# CITY OF ALBUQUERQUE

**Re: The Carlisle  
SW Corner of Carlisle/Central  
Grading and Drainage Plan  
Engineer's Stamp dated: 9/1/2015 (K17D69)**

*DRAINAGE REPORT*

*Carlisle Condominium Project*

**5 Culvert Plan**  
Scale: 3/4" = 1'-0"

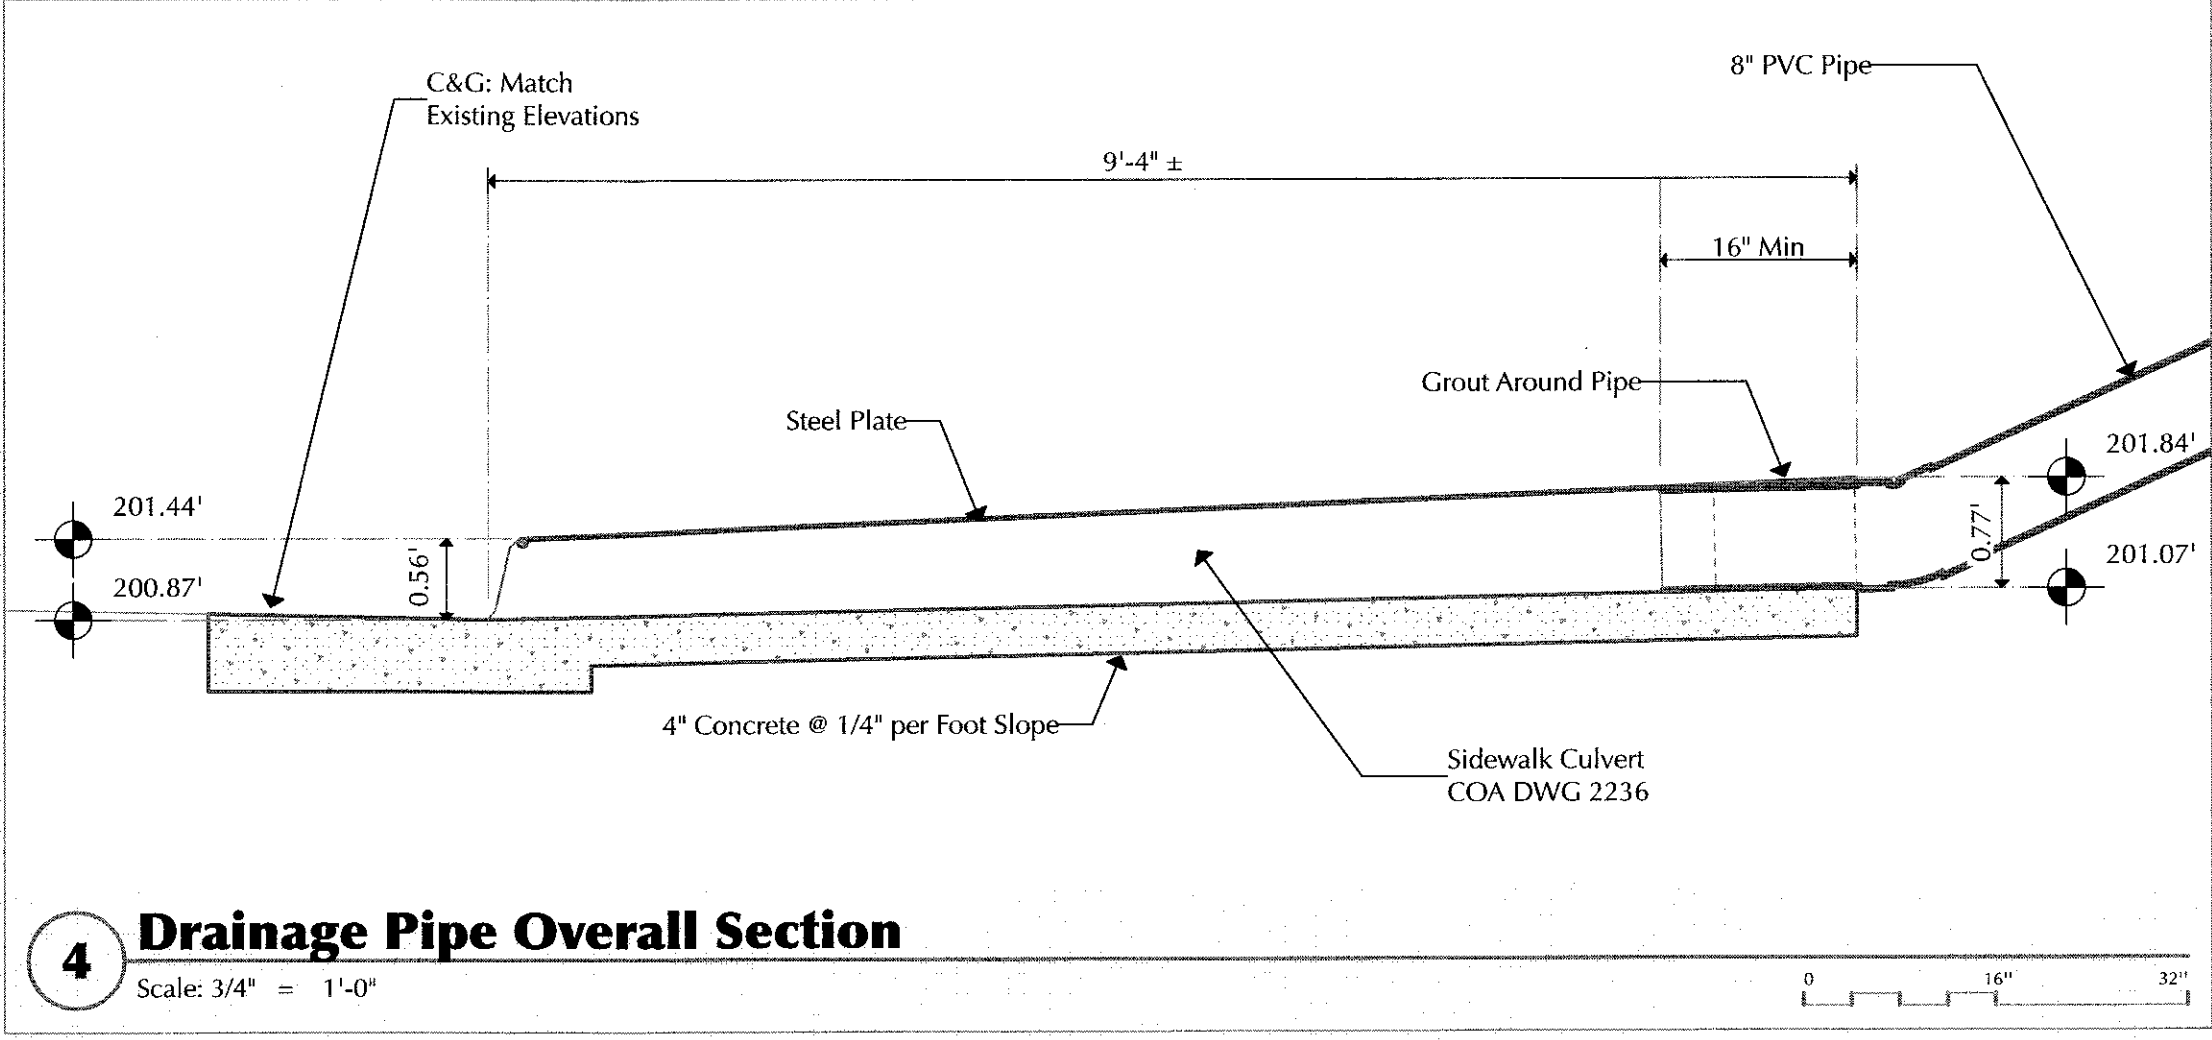
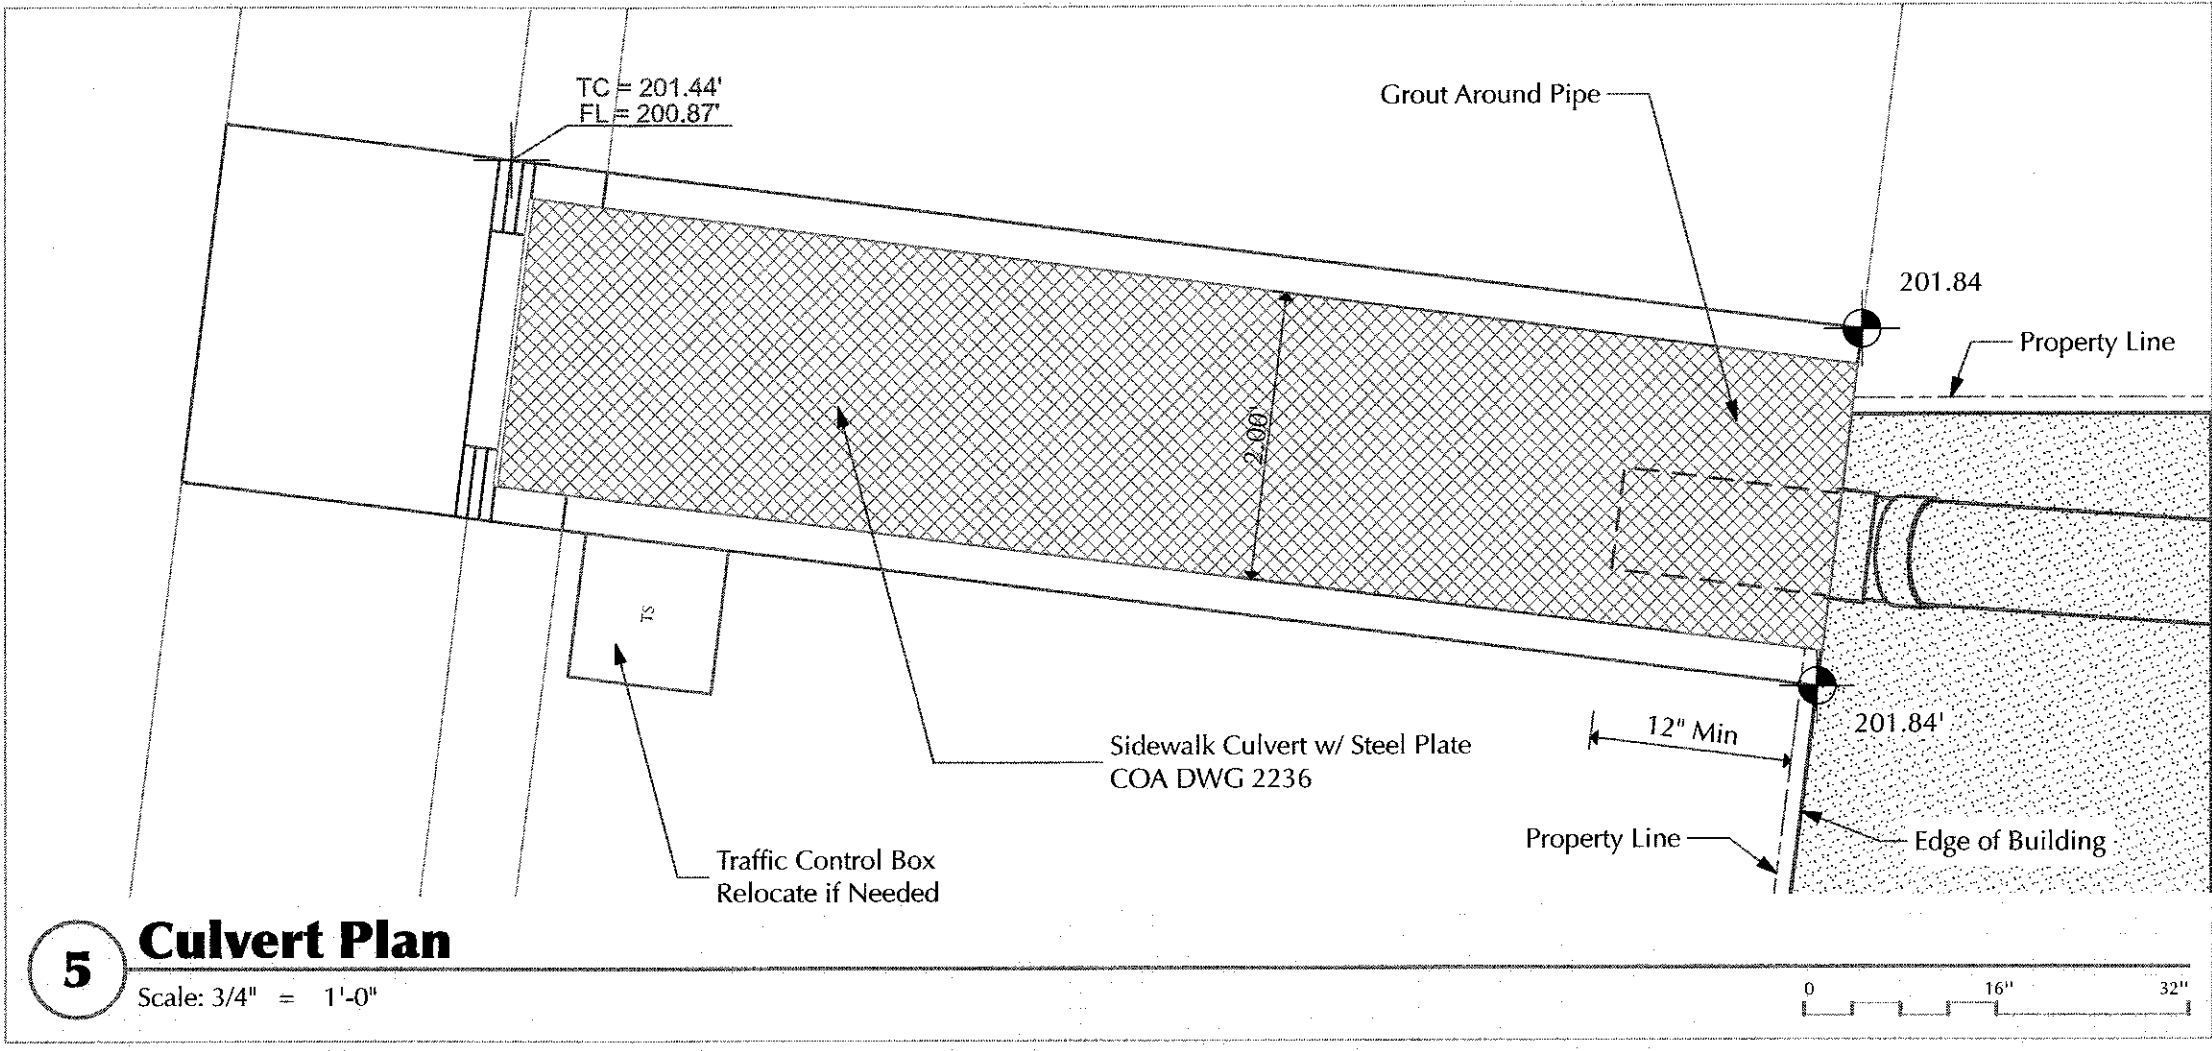
- Provide the type of surface in the storage tank (Impervious concrete, bitumen).
- Provide what the existing drives will be replaced with (Walkway, landscape).
- Provide what is in the areas to the north and west of the building.
- Provide a keyed note for the sidewalk culvert mentioning the city spec.
